ONSITE SEWAGE DISPOSAL SYSTEM DESIGN PLAN

FULTON MANOR VALLEY - LOT 9
 12159 FULTON ESTATES COURT
 FULTON, MD 20759

MEMORANDUM

RE: 12159 Fulton Estates Court
Fulton, MD 20759
"OSDS Plan"

SITE PLAN FOR BAT INSTALLATION

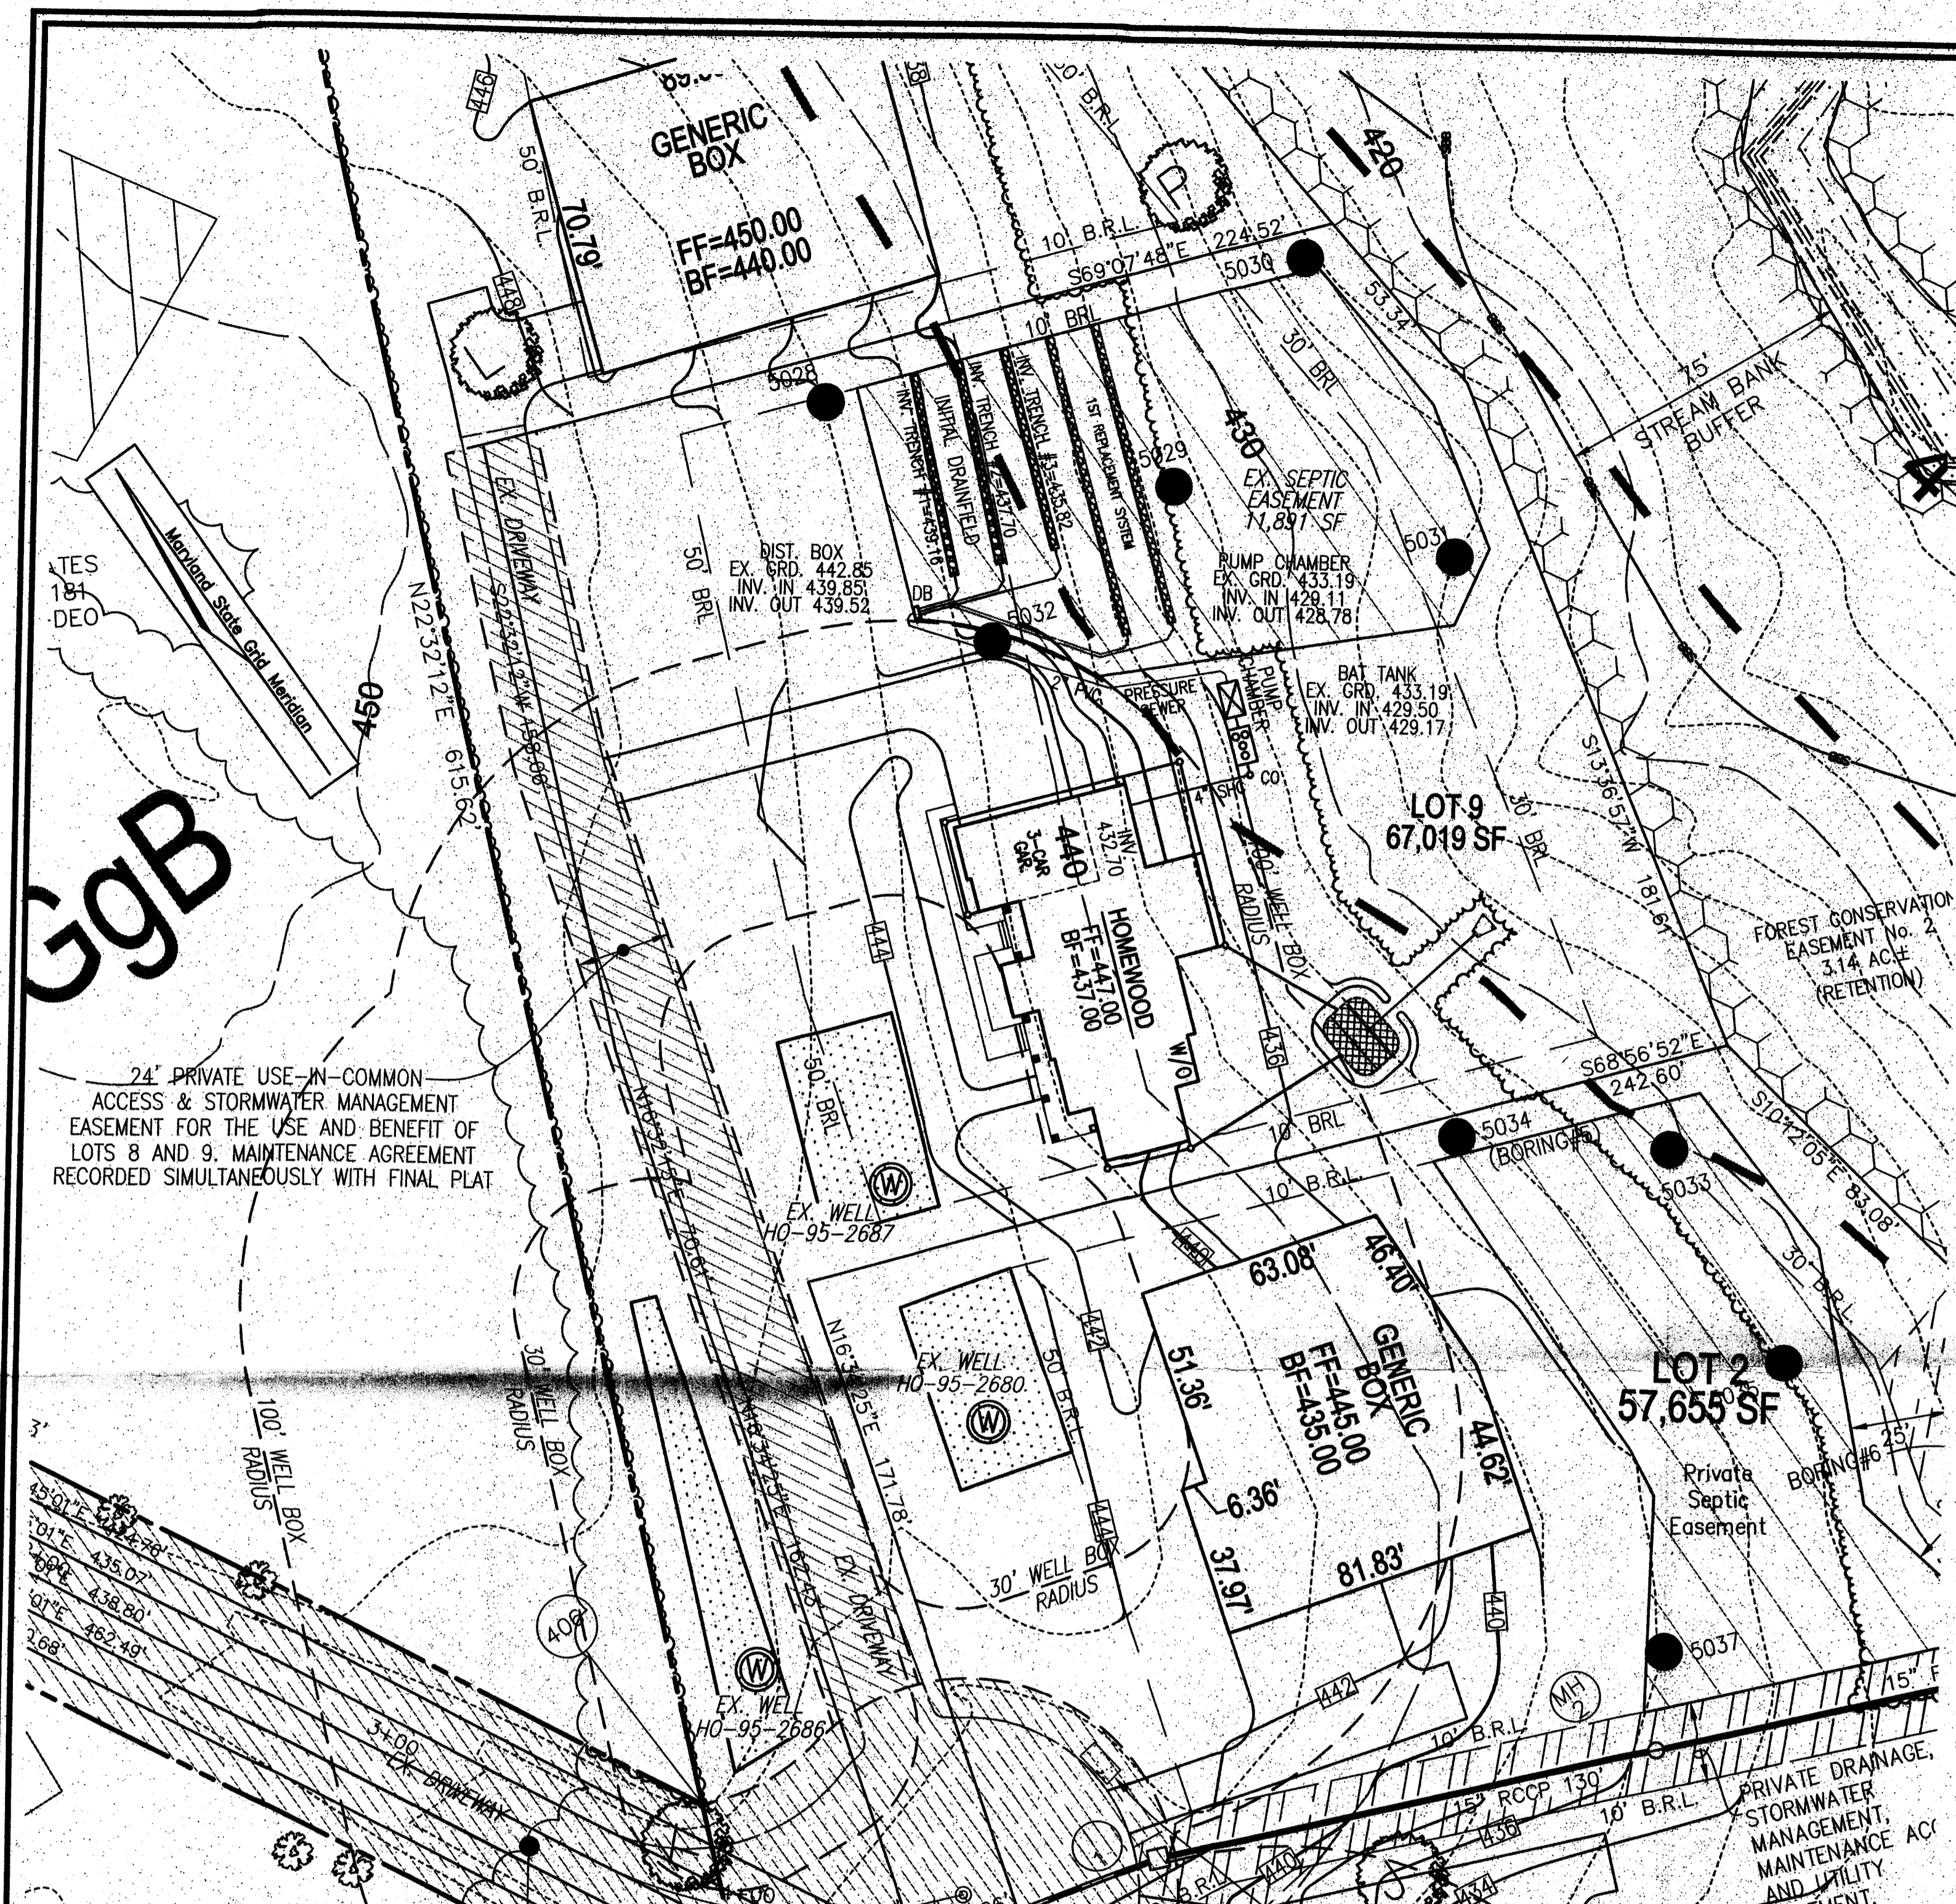
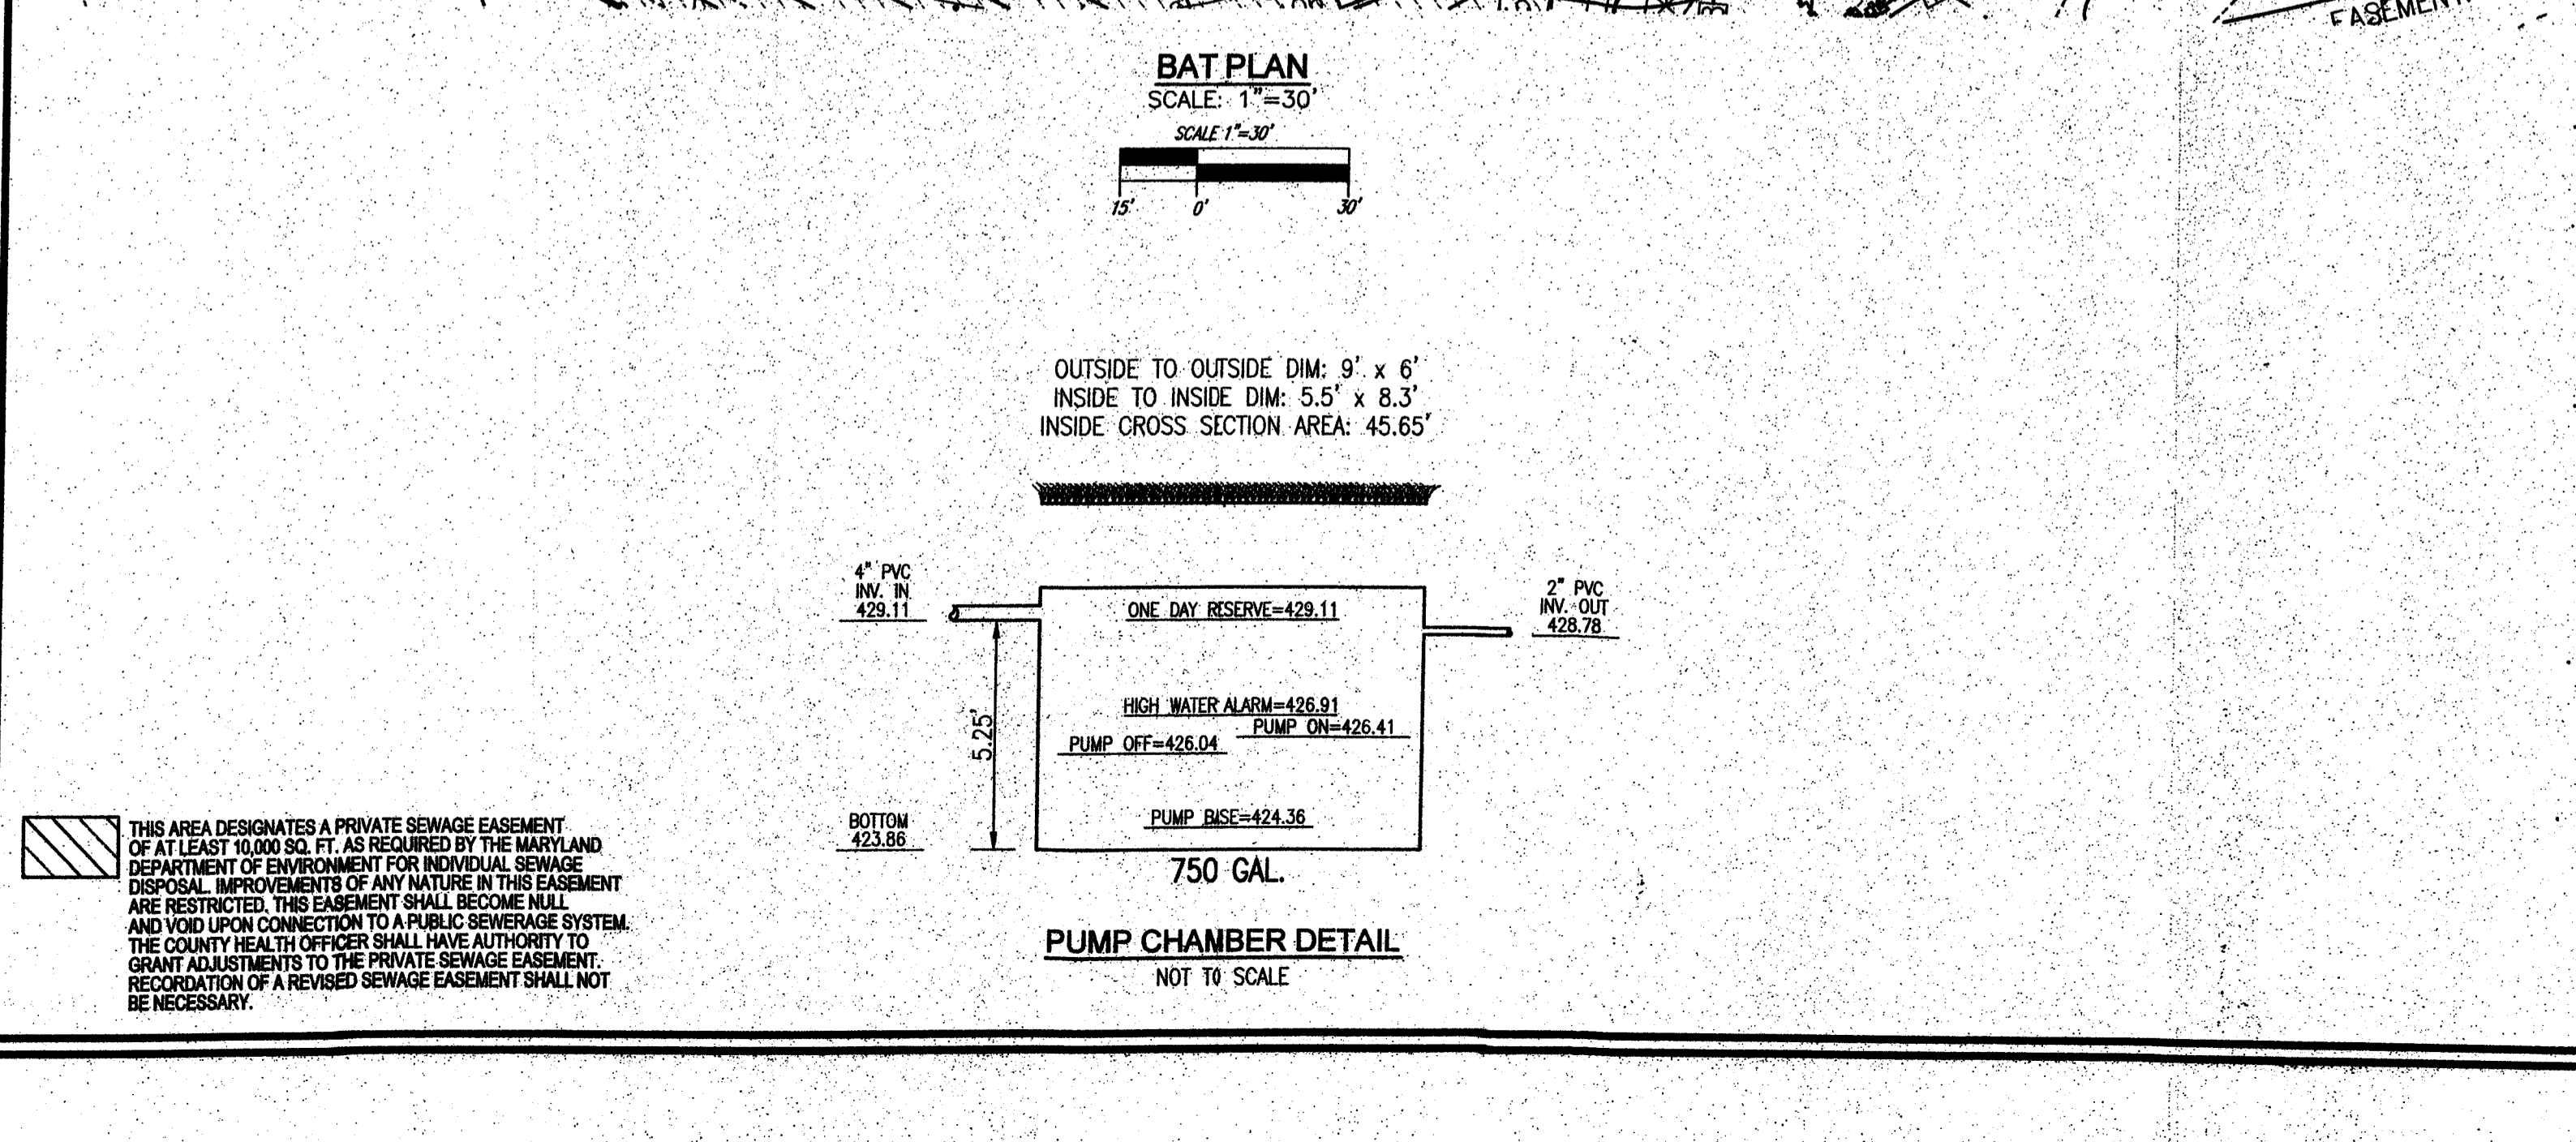
Attached are the computations that you asked for concerning the Fulton Manor Valley lot 9 BAT plan. I am pretty sure the pump specs were shown on the plan under the detail. They are however pretty small. They are also on the attached sheet. Let me know if you need anything else.
